# SERVICE BULLETIN

No. 487

Piper Aircraft Corporation

Control Shaft Collar Attachment Modification

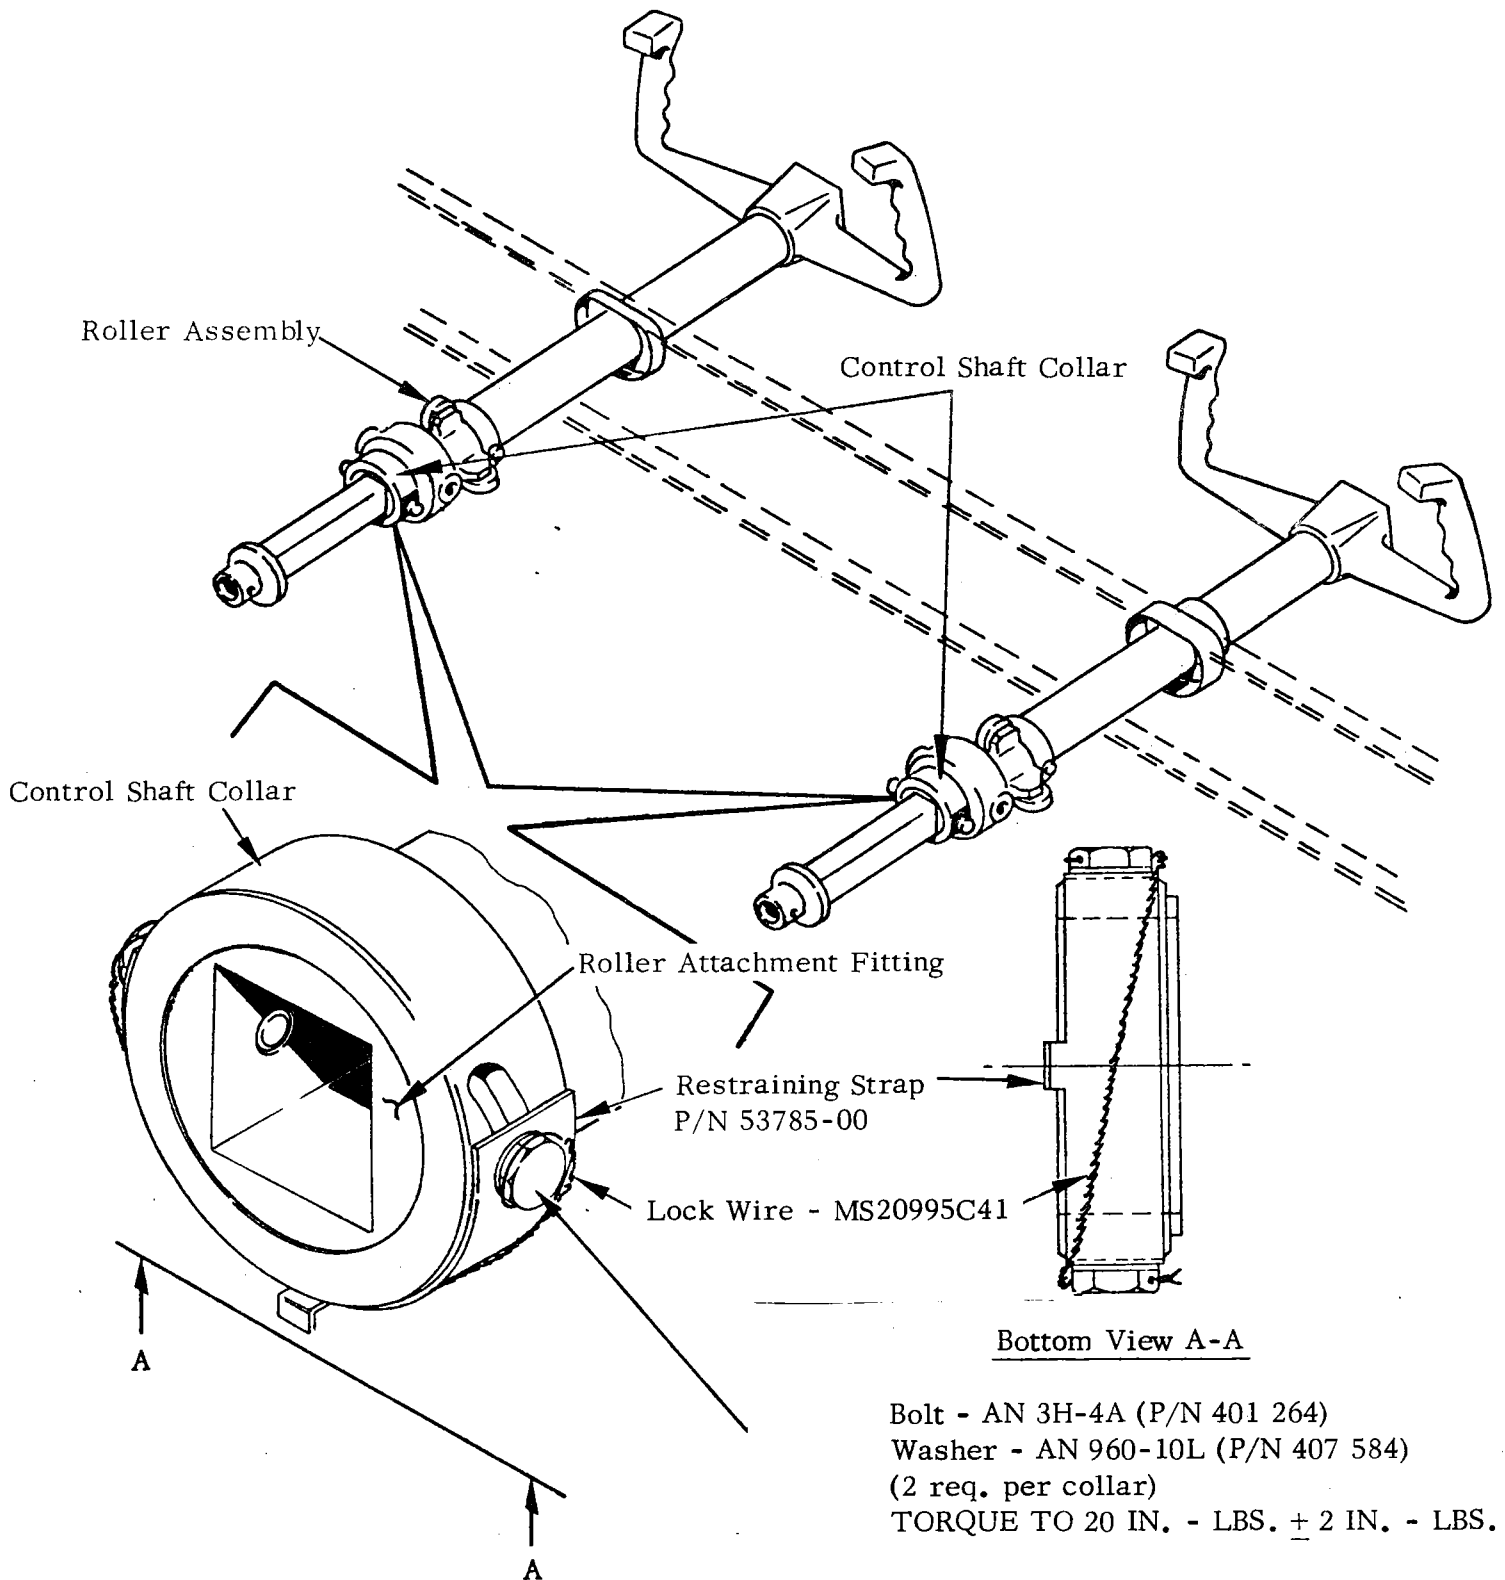
A recent report from the field indicates that the AN 3H3A bolts which attach the control shaft collar to the control shaft tube can be of insufficient length to allow proper bolt thread engagement. Should this condition exist, the bolts can become detached from the assembly, affecting control column function.

1. Refer to attached sketch; move control wheel to gain access to roller assembly. Rotate control wheel as required to gain access to each bolt.
2. Cut lock wire, as shown on sketch detail.

Bolt - AN 3H-4A (P/N 401 264)  
 Washer - AN 960-10L (P/N 407 584)  
 (2 req. per collar)  
 TORQUE TO 20 IN. - LBS.  $\pm$  2 IN. - LBS.

**NOTE:** Inspect to insure that the bolts are not protruding through the Roller Attachment Fitting by placing a .040 feeler gage between the fitting and the square tube. Should the bolt protrude, add one (1) additional AN 960-10L washer under the head and recheck clearance at 20 IN. - LBS.  $\pm$  2 IN. - LBS.

4. Install AN 3H4A bolt (Piper part number 401 264) and AN 960-10L washer (Piper part number 407 584).
  5. Using a 3/8" socket and a low-scale, inch-pound torque wrench, tighten bolt to 20 inch-pounds  $\pm$  2 inch-pounds; if this torque value can be maintained without stripping the threads repeat steps 3, 4, and 5 on other bolt.
    - a. If 20 inch-pounds  $\pm$  2 inch-pounds torque value cannot be maintained on either bolt, contact the factory (Lock Haven Facility) Customer Service Dept. for further information.
  6. After completion of above steps, lock-wire bolts (see sketch).
  7. Repeat steps 1 through 6 with other control wheel.
  8. Make appropriate log book entry indicating compliance with this Service Bulletin.
1. Four (4) each per aircraft AN 3H4A bolt, Piper part number 401 264;
  2. Five (5) each per aircraft AN 960-10L washer, Piper part number 407 584.
